Sheringham Shoal and Dudgeon Offshore Wind Farm Extension Projects

The Applicant's Comments on the Maritime and
Coastguard Agency's Deadline 6 Submission

Document Reference: 21.11

Figure 1 Comparison – NRA Worst Case Modelling vs MCA Prediction of Future Case

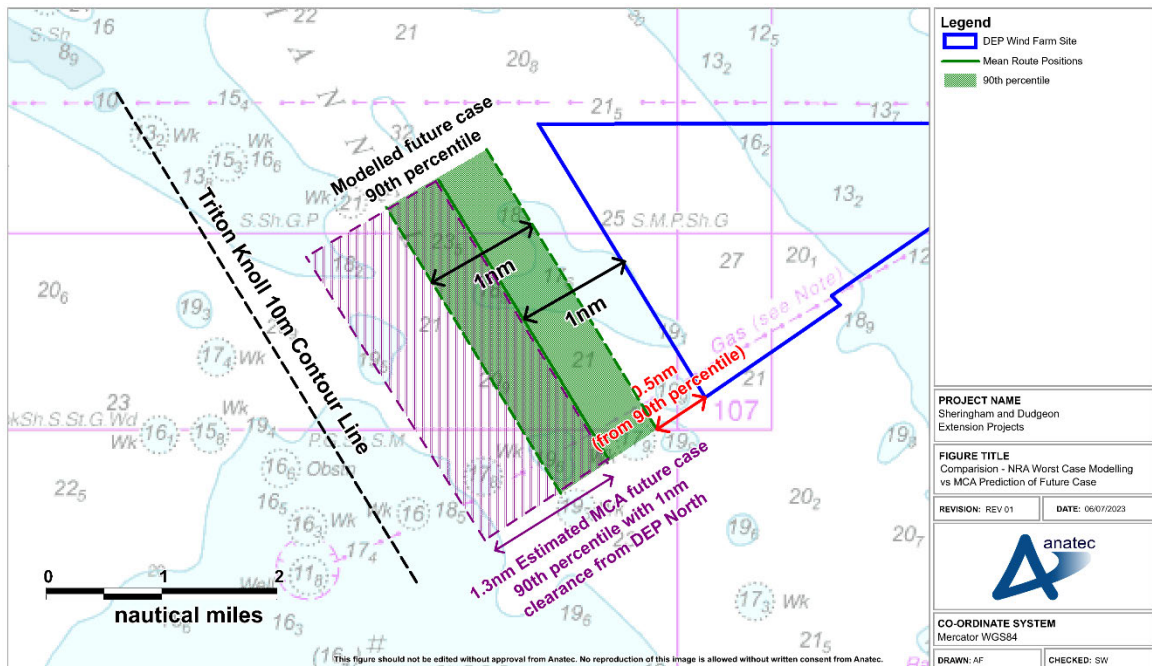
"it is likely that 90% of vessels will be constricted into a navigable space of 1NM wide. This does not appear to have been considered for assessing the potential frequency of encounter and collision likelihood scores within the hazard log" and that based on this *"The predicted increase of 13% collision frequency at current traffic levels may have been underestimated, in which case changes to the red line boundaries must be considered"* (emphasis added).
16. At ISH6 the MCA would quantify this as a constriction of the 90th percentile traffic width to 1.3nm (Page 1 of ISH6 Maritime and Coastguard Agency's Deadline 1 Representation [AS-044]) when giving a buffer of 1nm to the DEP-N array area.
17. This was reiterated at Deadline 5 where in answer to Q3.19.1.2 the MCA stated:

"When a safety buffer of 1NM is applied to the DEP North boundary, our assessment is that vessels will be constricted into a channel 1.3NM wide." [REP5-081].
18. In discussion with the MCA the Applicant has clearly demonstrated that the collision risk modelling within the NRA has considered a constriction of traffic to a width of 1nm and therefore the predicted increase in collision frequency was not an underestimation. Charts to this effect were included in the Applicant's Deadline 5 submission [REP5-050].
19. At ISH7 the MCA, Trinity House and Chamber of Shipping all agreed, when viewing Figure 1 below, that the assumptions upon which modelling were based represented a worst-case scenario with the MCA stating:

"from this conservative view this is going to be the maximum allision and maximum collision"
20. The Applicant believes that the MCA should now be satisfied that collision frequency rates have not been underestimated and therefore a consideration of a change to the red line boundary is no longer required. The Applicant fails to understand why the MCA has not withdrawn its objection in the light of the clarifications it has provided as to the analysis which it had conducted. As has been demonstrated, the analysis was significantly more conservative than the MCA had assumed. It is not reasonable for the MCA to maintain an objection when a point of concern has been comprehensively addressed in this way.

Figure 2 Vessels within 1.5nm of Dudgeon Offshore Wind Farm

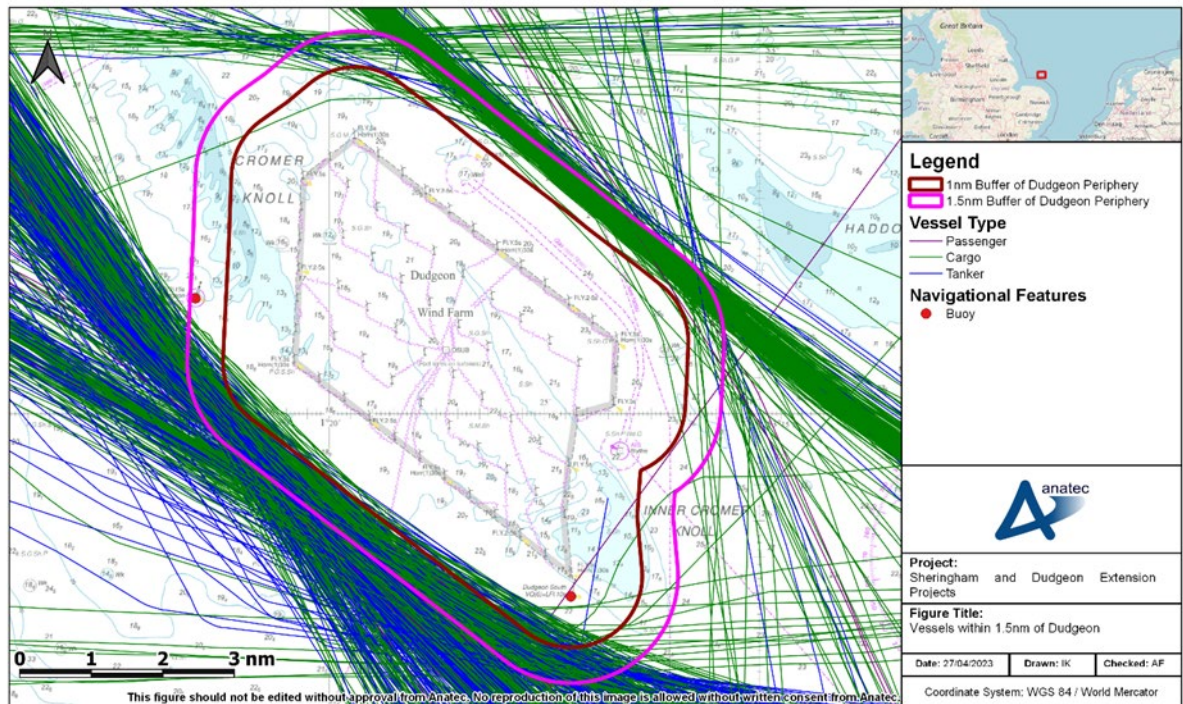
21. The MCA maintains that in passage planning, vessels will leave a 1nm 'safety buffer' to offshore structures [REP1-117].
22. The Applicant acknowledges that some vessels may plan for a 1nm minimum safe passing distance; however, there is no mandatory distance for passing structures. The Applicant has provided extensive evidence from several wind farms of vessels passing closer [REP5-050], including an example from the existing Dudgeon Wind Farm at the location of the proposed development [REP3-031] (see Figure 2).

23. The MCA position suggests the 90th percentile of traffic would sit at 1nm from any structures. Whilst there is safe navigable area to the west for this to occur, applying this assumption when also maintaining a worst-case constriction to 1nm traffic width, would only reduce allision risk (as vessels would be passing further from the structures) and therefore not represent a worst case for both collision and allision.

Figure 3 MCA Justification for change to buildable area

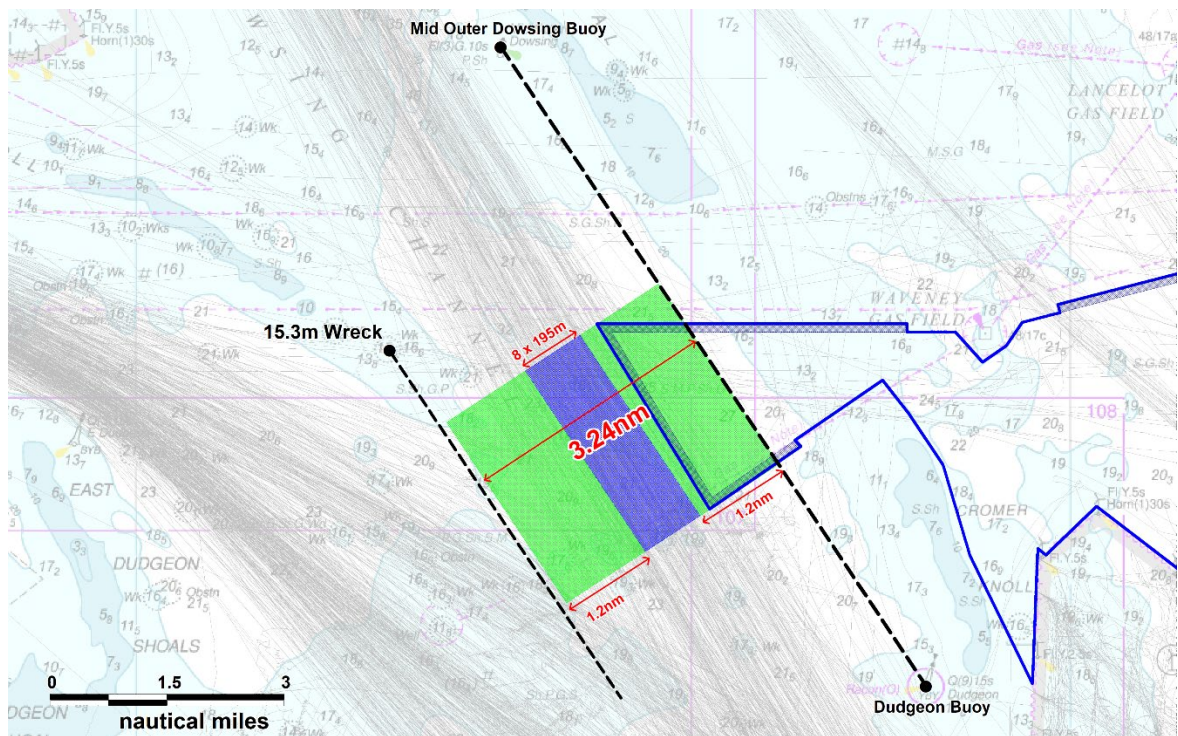
30. When applying this width from what the MCA had identified as the controlling depth of 15.3m of the wreck in the west of the channel this correlates with the line formed by the Mid-Outer Dowsing buoy and Dudgeon buoy. Figure 3 below illustrates the MCA's original calculation.

31. However, in doing so, the MCA sought to apply a combination of PIANC guidance¹ and Nautical Institute and The World Ocean Council guidance². These are primarily intended to be used where there are two wind farms either side of the shipping route, which is not the case here. As a proxy for the other (non-existent) wind farm, the MCA has treated a wreck at 15.3m depth as fixing the boundary of the (non-existent) other wind farm.

33. The Applicant does not agree with the use of this guidance in this way by the MCA for three reasons;

Figure 4 Application of MCA Safe Sea Room calculation from 10m controlling depth

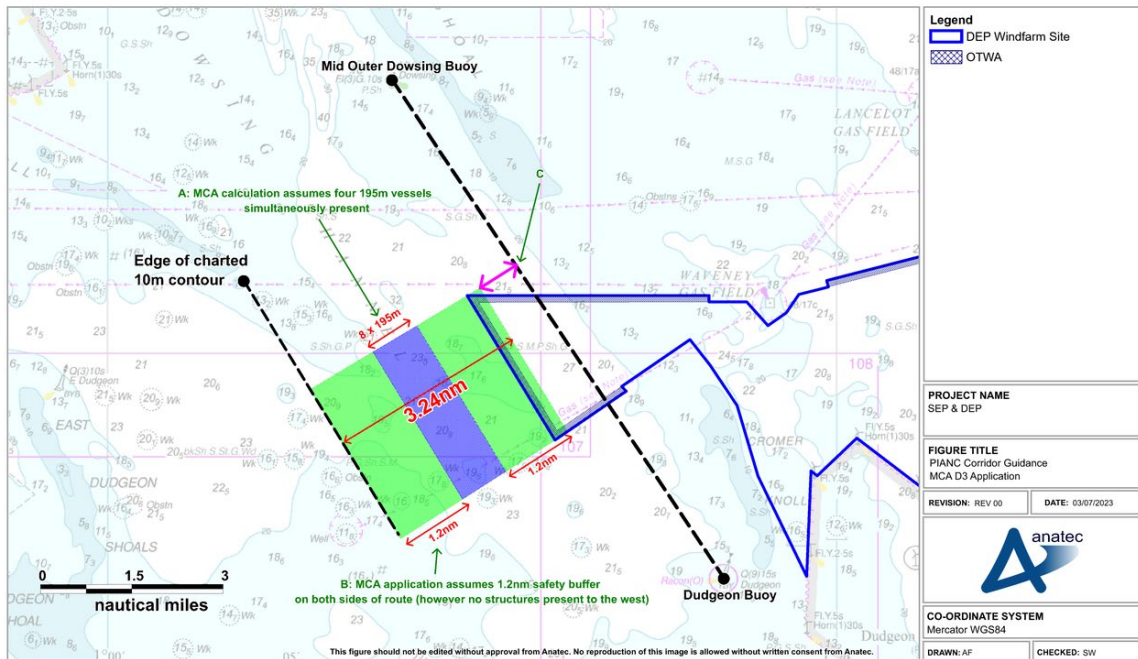
35. The MCA is using the 15.3m wreck as the controlling depth in the Outer Dowsing Channel. The Applicant considers the 10m contour as the controlling depth and this is supported by Trinity House (Figure 4 of Deadline 5 Submission [REP5-096]) and reiterated at ISH7 where Captain Harris stated: "*we are marking the 10m contour which we consider to be the controlling depth.*" (49:32 [EV-095]). The controlling depth in a sea route is fundamental to its marking for safe passage. This is a core area of expertise of Trinity House, whose expert regulatory remit specifically covers marking channels and hazards.

36. In light of this helpful clarification by Trinity House, the Applicant has considered what the MCA's position might be assuming that it may conclude that the same calculation should be applied but be taken from the correct starting point for the controlling depth i.e. the 10m contour. Using the same MCA calculated width of 3.24nm but starting from the 10m contour the overlap with DEP-N boundary is as shown Figure 4 below.

37. The mistake regarding the controlling depth is a fundamental error of fact by the MCA which undermines its case for a no structures area set by the line between the Mid-Outer Dowsing buoy and Dudgeon buoy. When the correct controlling depth (i.e. 10m) is applied a much smaller no structures area results.

Figure 5 Vessels transiting within 1.2nm of 15.3m wreck identified by MCA as controlling depth in Outer Dowsing Channel

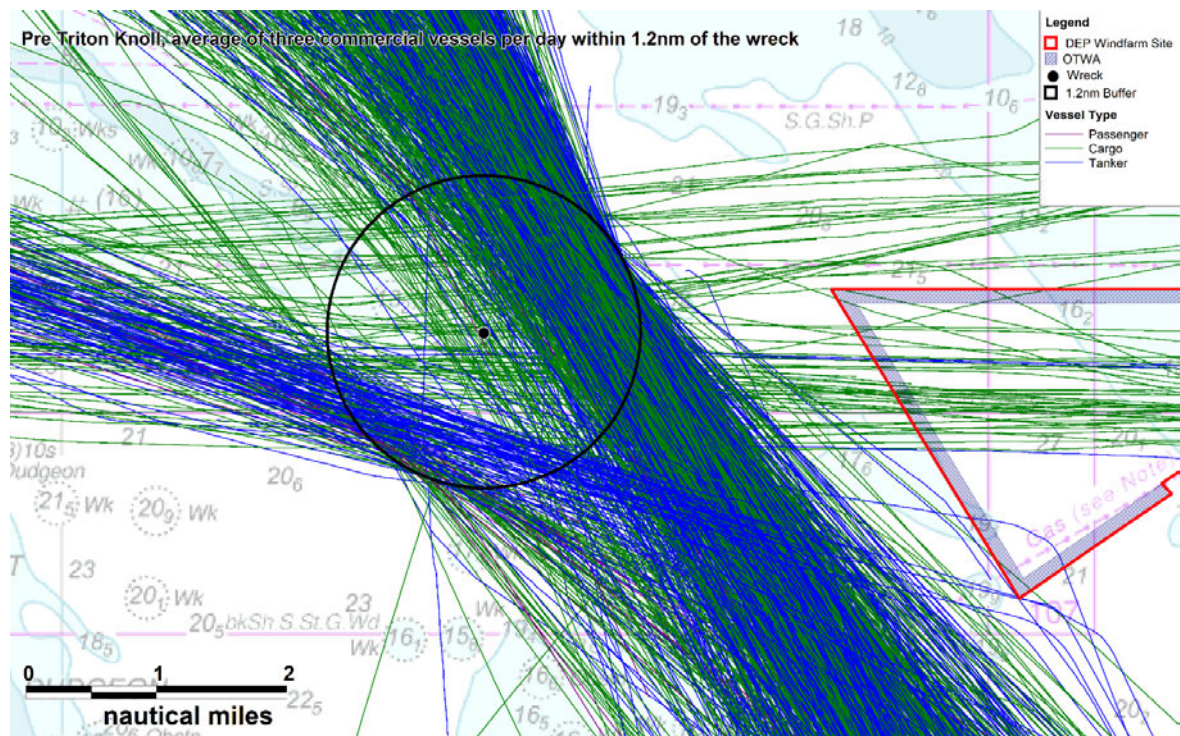
41. The second reason why Applicant cannot agree with this calculation is the assumption vessels would apply a 1.2nm buffer to the 15.3m wreck. A significant amount of traffic in the baseline data transited within 1.2nm of this wreck as shown in in Figure 5 below. If vessels were to apply such buffers to controlling depths then it would render many of the channels in the area unsafe in the view of the MCA. It appears that the MCA is seeking to make an exception in this case which is unsubstantiated by traffic evidence and unsustainable.

42. The MCA have previously stated that the 90th percentile traffic width is 2.5nm [REP1-117] which is in agreement with data collected in traffic survey and presented in the NRA. In Figure 1 of their Deadline 5 submission (Deadline 5 (D5) Submission - Responses to the Examining Authority's Third Written Questions (WQ3) [REP5-081]) the MCA present the current sea room as 3.1nm. By the MCA's own numbers, the 90th percentile width of traffic sits 0.3nm from the extent of the available sea room $((3.1\text{nm}-2.5\text{nm})/2)$.

43. Furthermore as the MCA's own measurement of current sea room available in the Outer Dowsing Channel is 3.1nm, it must be noted that this is 0.14nm less than what they present as the safe minimum width with the calculation using its application of the guidance^{1, 2} (**Maritime and Coastguard Agency - Responses to the Examining Authority's Third Written Questions- Figure 1 [REP5-081]**).

Figure 6 MCA Calculation based on 130m vessel LOA against 10m controlling depth

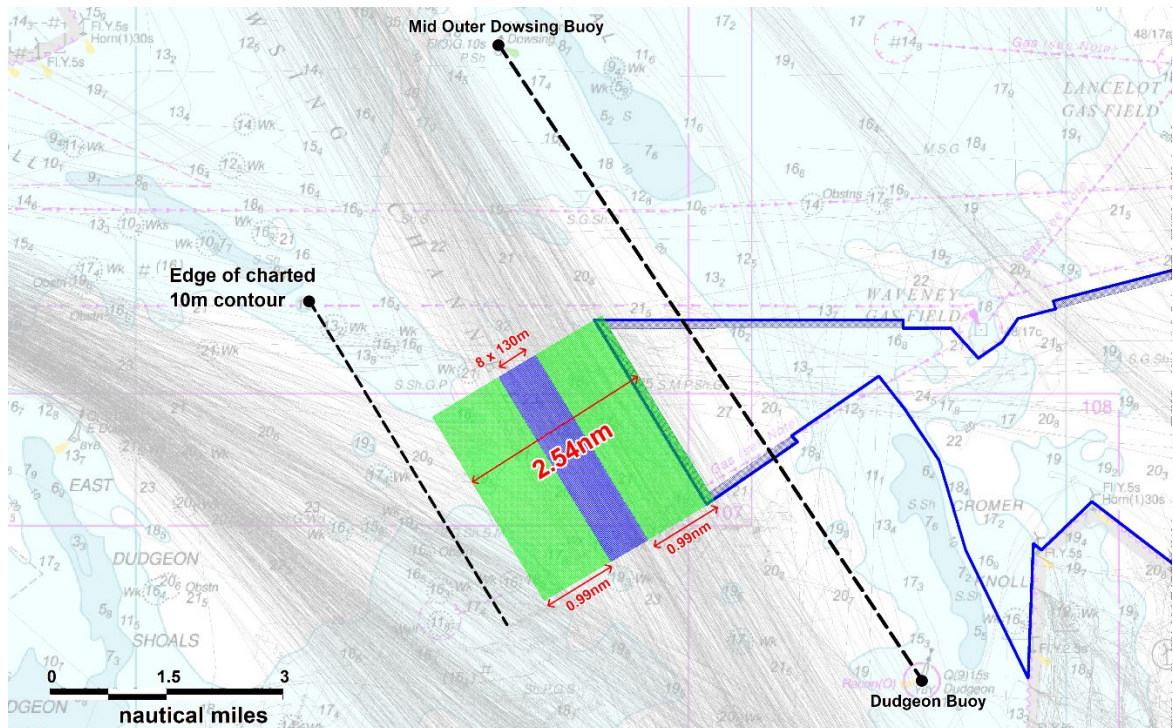
45. The third reason the Applicant disagrees with the calculation is due to the use of 195m as vessel length. Only 2% of vessels using the Outer Dowsing Channel have a length >195m. The likelihood of four 195m vessels passing within 30 minutes of one another is also low. Additionally, as only 0.1% of the time there is more than 3 vessels passing western boundary of DEP-N this further reduces the likelihood of the scenario the MCA bases its calculation on. The probability of this scenario presenting within the operational lifetime of the project is remote given it represents a 1 in 3,567 year occurrence.

46. Using a vessel length of 130m which is the mean LOA for vessels passing DEP-N, and starting from the 10m controlling depth agreed with Trinity House (whose expertise whose expert regulatory remit specifically covers marking channels and hazards as already noted) then the same calculation brings the result shown in Figure 6 below.

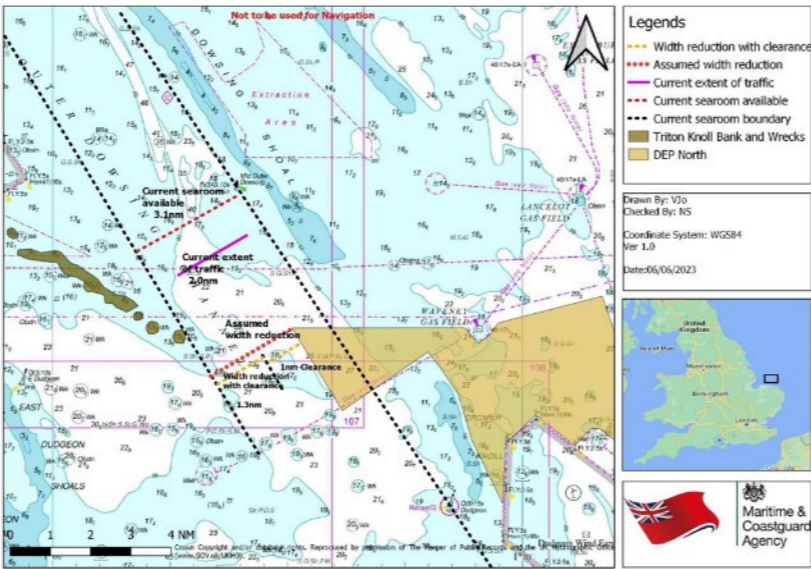
Q3.19.1.2 b1	<p>b) Provide your version of the Applicant's Figure 7.2 of the submitted Navigational Safety Technical Note [REP3- 031], showing anticipated remaining sea room for ships, including safety buffers necessary.</p>	<p>b) The image below (Figure 1) shows our assessment of the anticipated safe sea room for vessels west of DEP North which includes a 1NM clearance from the boundary:</p>	<p>As shown within Figure One (Safe Sea Room Assessment) of the MCA Deadline 5 submission [REP5-054] water depths within the Outer Dowsing Channel (identified by the dashed line within figure one) include water depths as low as 11.3 metres, with nautical charts of the area showing the actual controlling depth of 10.1 metres. Whilst the MCA correctly identify that vessels will always passage plan to avoid depths they cannot safely navigate in, there are number of key points the MCA do not highlight in their responses.</p> <ul style="list-style-type: none"> • If those vessels requiring a water depth of deeper than 14 metres are only navigating in the very constrained sea area in the east of Outer Dowsing Channel (approx. one mile); this would then mean even with DEP North in situ the traffic would have more sea room once past this constrained area 'if' they were concerned by this depth. • Water depths are variable (including the channel between DEP and SEP) through the area, and the wider sea area and vessel constrained by their draught are known to navigate using the DWR to the east.

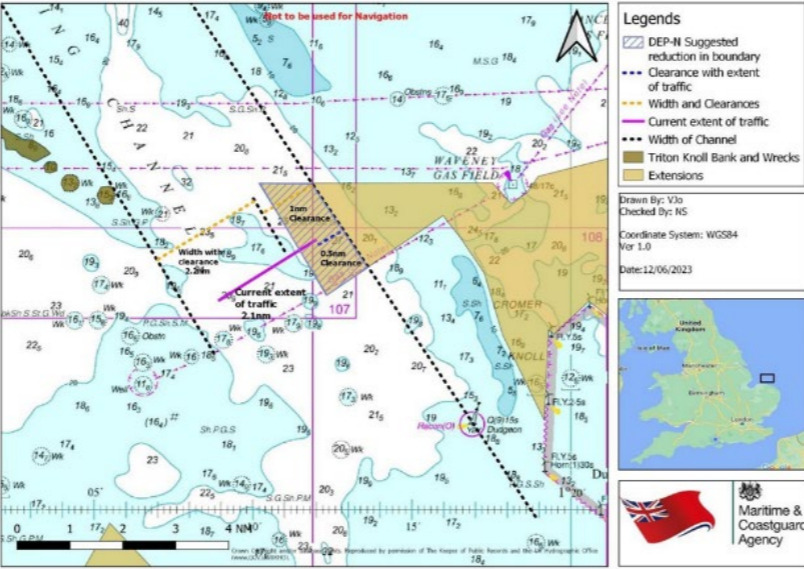
Q3.19.1.10	<p>Details of Obstacle/Turbine Free Areas</p> <p>If the MCA considers that the only solution to address the concern about navigational safety to the west of the proposed DEP-N windfarm site is to have a turbine/obstacle free area, can this be clearly shown on a map/chart of the area within the DEP-N boundary that this would need to relate to.</p>	<p>The image below (Figure 2) shows a line running through the Mid-Outer Dowsing buoy and Dudgeon buoy and MCA recommends the boundary is reduced to this line, as a minimum:</p>	<p>See response to Q3.19.1.2 b2. The NRA [APP-198] has demonstrated that the remaining sea room available off DEP North is considered acceptable for safe navigation.</p> <p>As per response to Q3.19.1.8, the Applicant has submitted evidence [REP5-050] that vessels can and do pass closer than 1nm from operational wind farms.</p> <p>The MCA have proposed a mitigation without justification. When asked to provide the background evidence to support their position relating to the matters discussed at ISH6, the MCA provided a calculation for adequate sea room to allow four vessels to safely pass each other in the Outer Dowsing Channel [REP3-134]. This calculation is analysed and comprehensively refuted by the Applicant in Section 2.4 of this document.</p> <p>The Applicant has carried out sensitivity analysis on the proposed mitigation and found a reduction in collision risk of 3% over the study area which would not change the expected number of collisions over the operational lifespan of the project [REP3-031].</p> <p>Figure 2 (Recommended Boundary Amendment) of the MCA submission at Deadline 5) illustrates measurements of widths and clearances which are contradictory to other positions put forward by the MCA and do not align with the baseline data or the assessment of safe sea room by Trinity House (whose expert regulatory remit specifically covers marking channels and hazards).</p>
